Addendum: **1**
Date: **10/28/2024**
Project: **Purdue Fort Wayne
Ginsberg Hall Chiller & Control Air Replacement**
Comm #: **24635**

PURDUE UNIVERSITY FORT WAYNE
GINSBERG HALL CHILLER & CONTROL AIR REPLACEMENT - 2024
 Hamlett Dr.
 Fort Wayne, Indiana 46835

SHEET:
E201

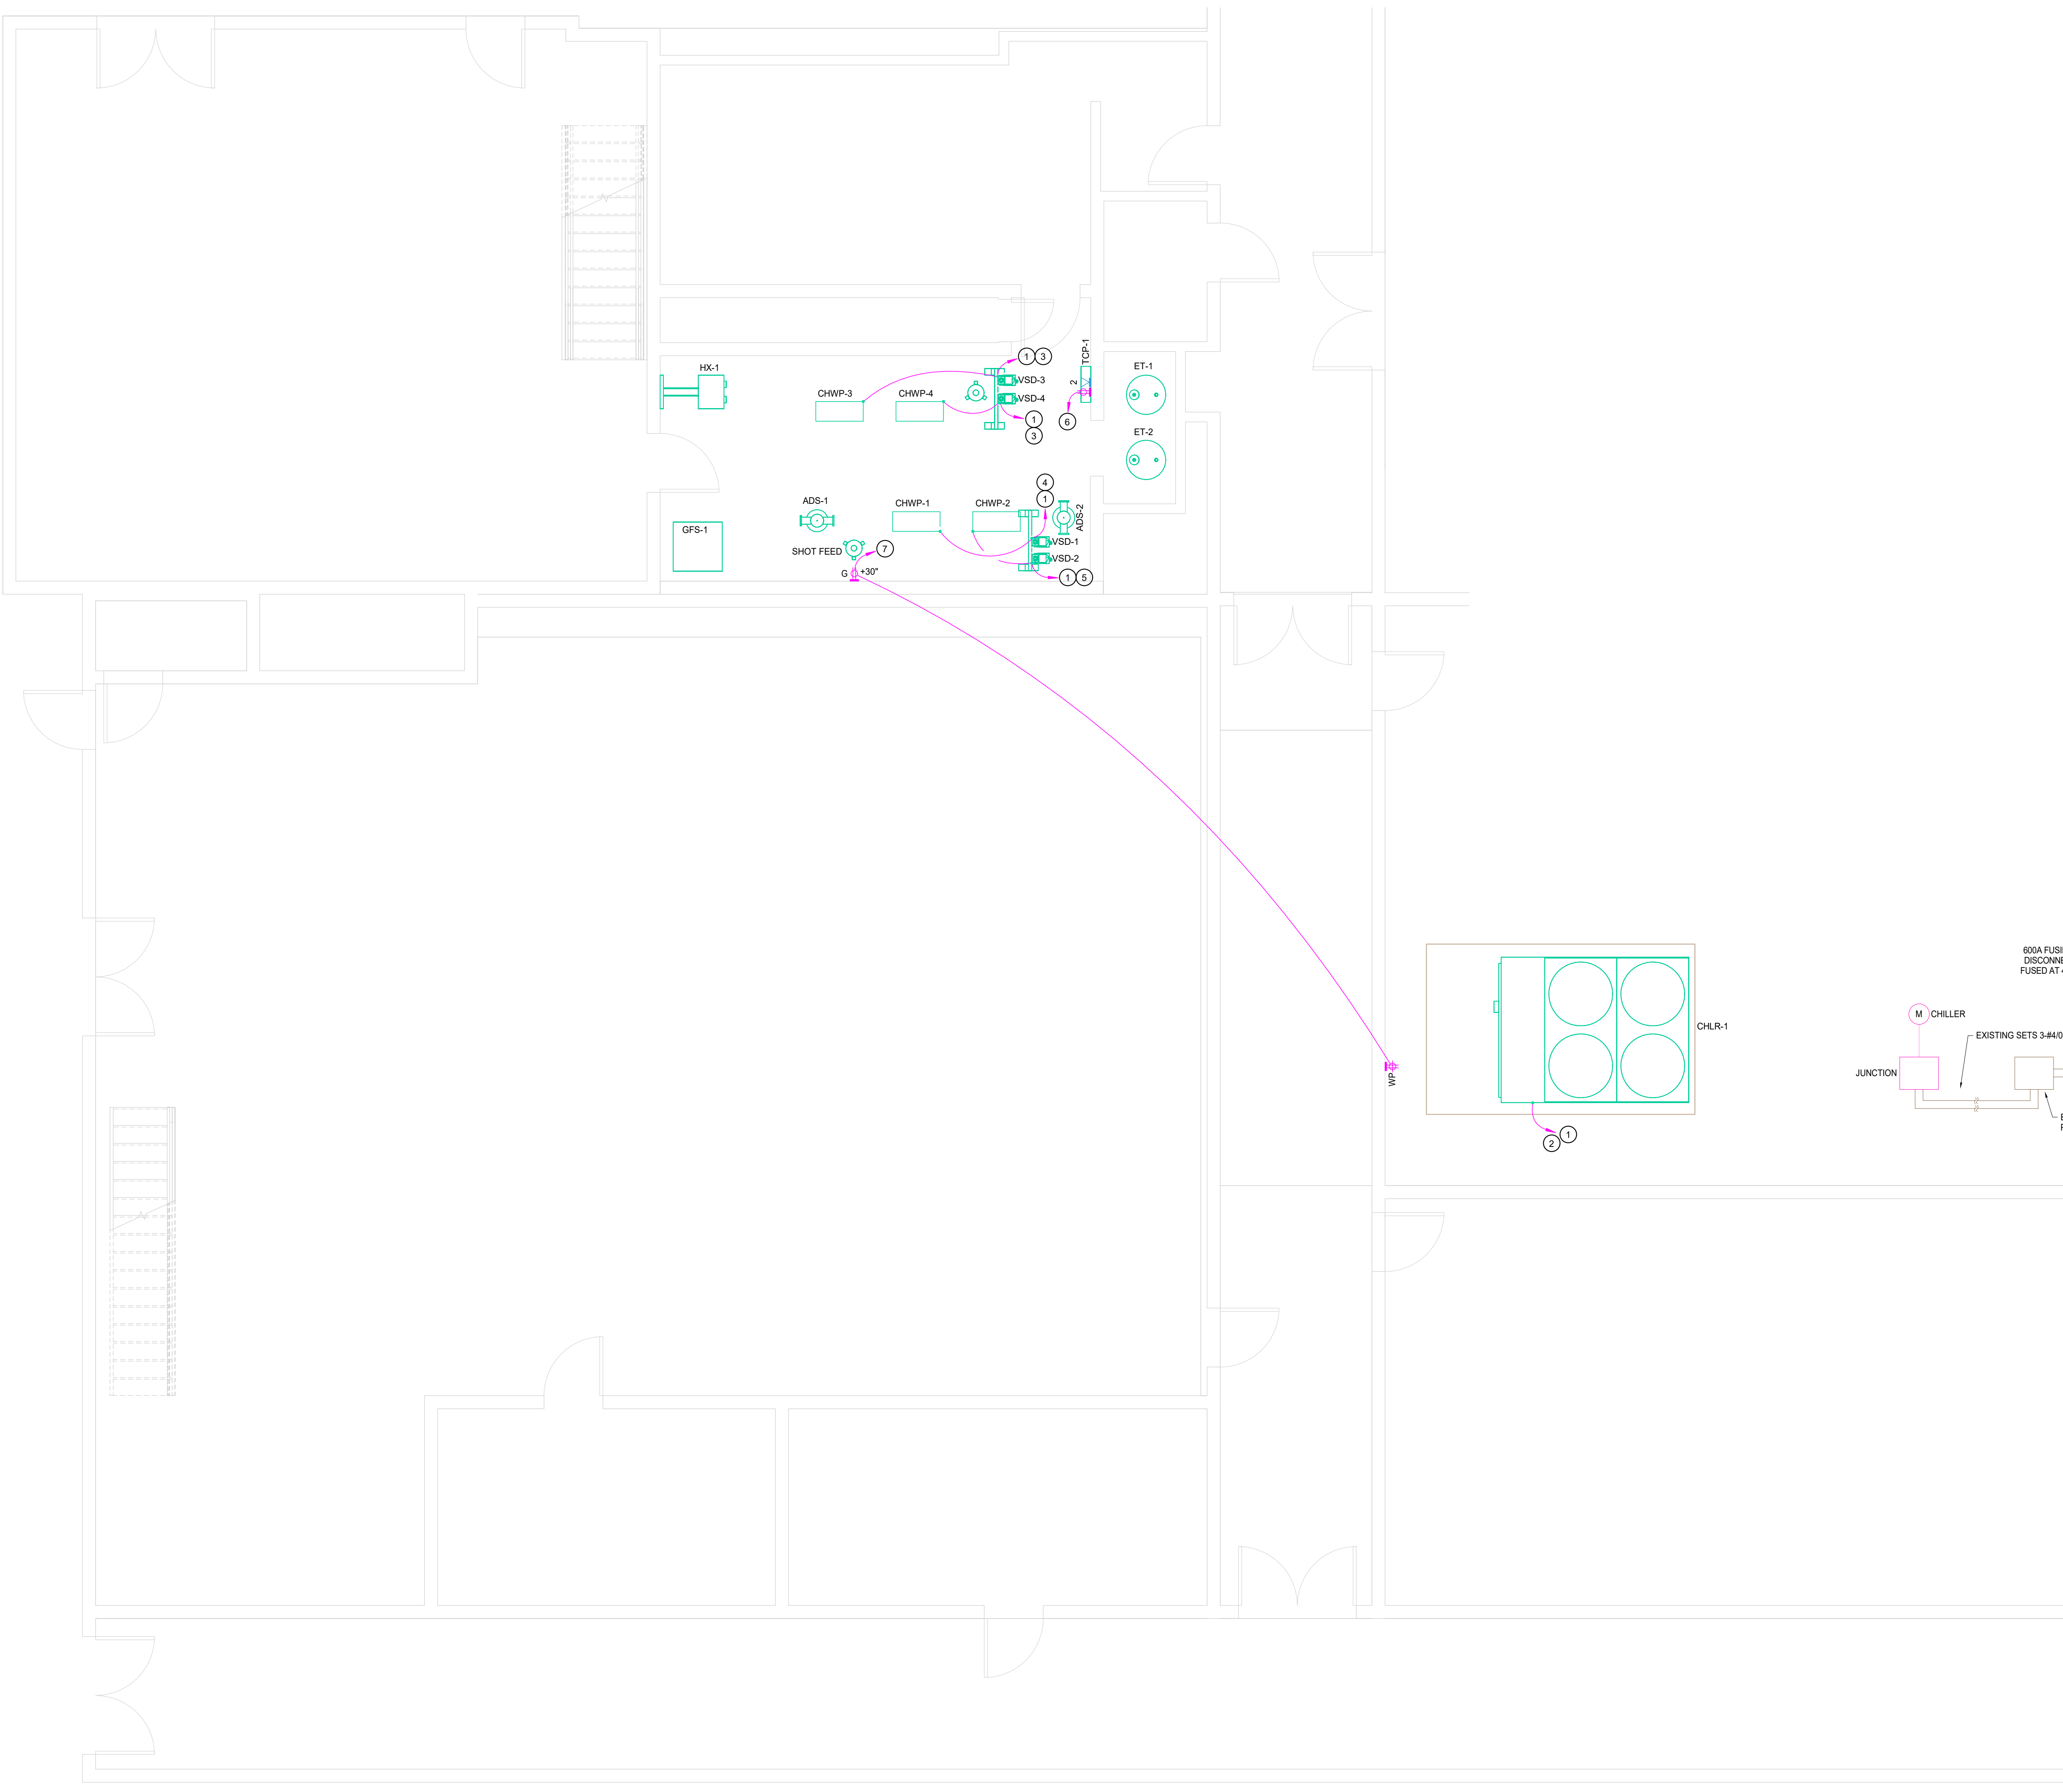
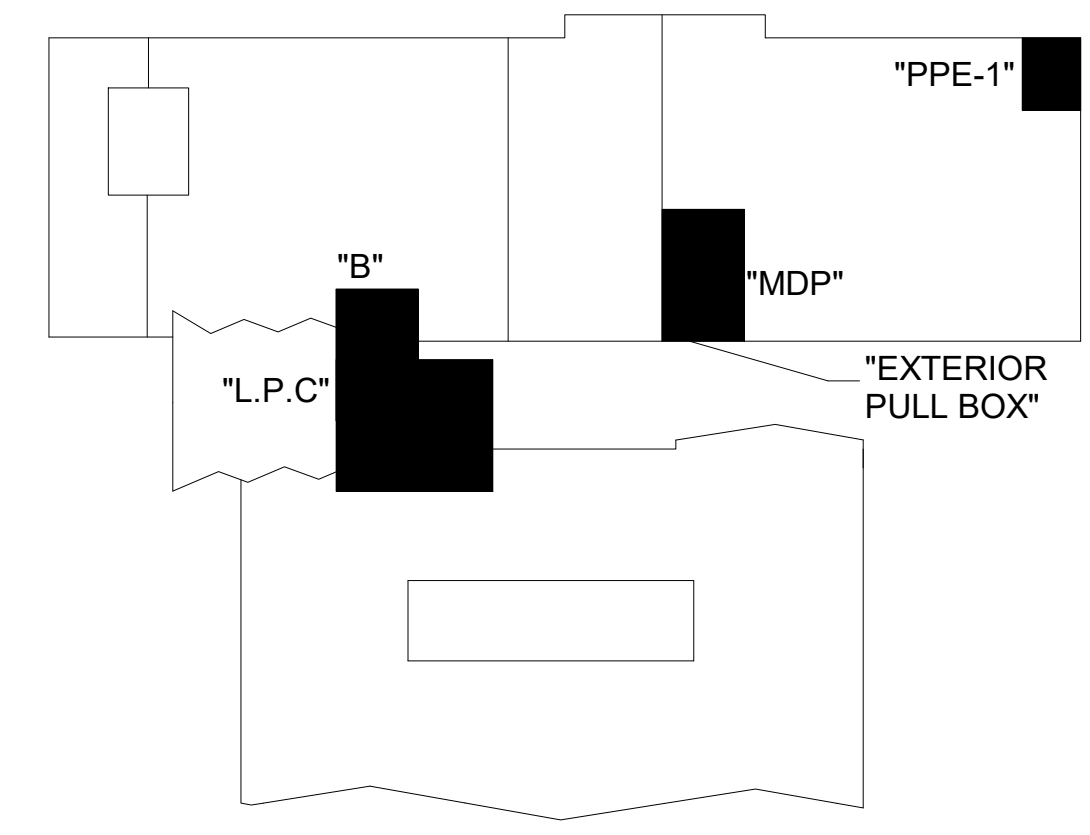
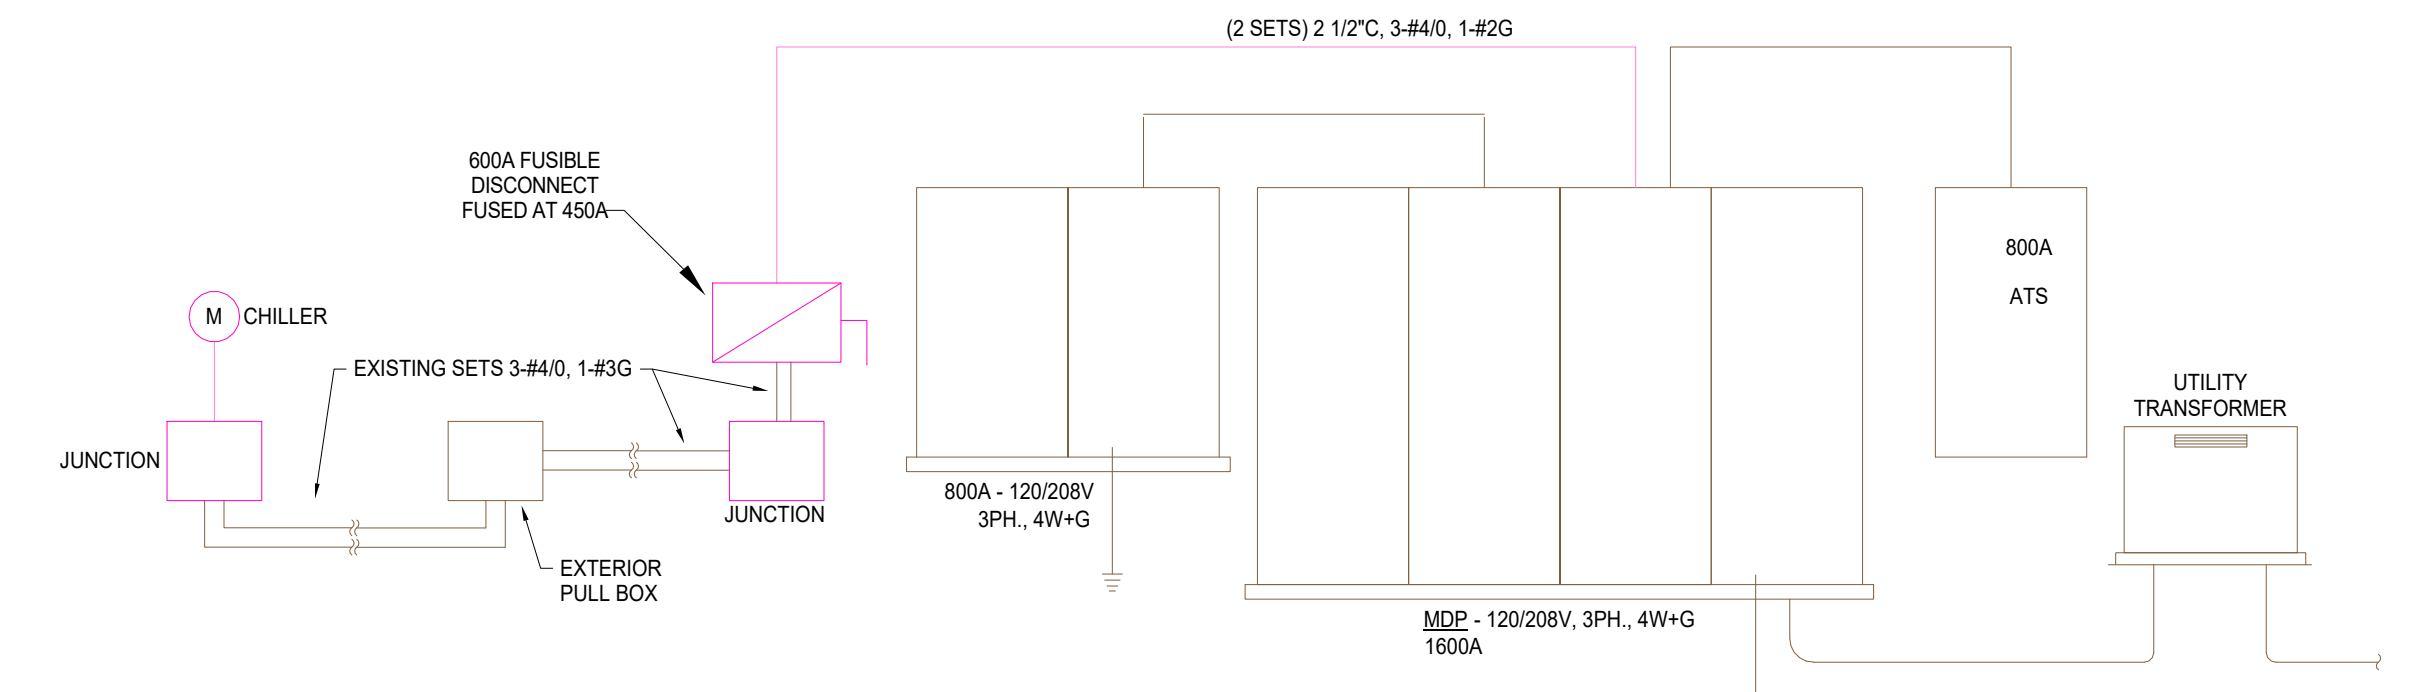
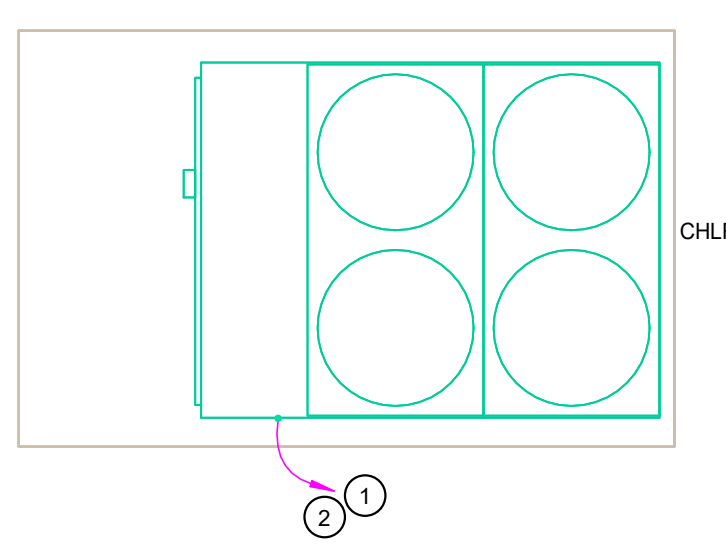
Item #3: Drawing Sheet E201

- A. All new light fixtures and controls to be removed from scope of work. Refer to sheet E-201 for revised plan notes and removal of lighting plan and emergency detail.
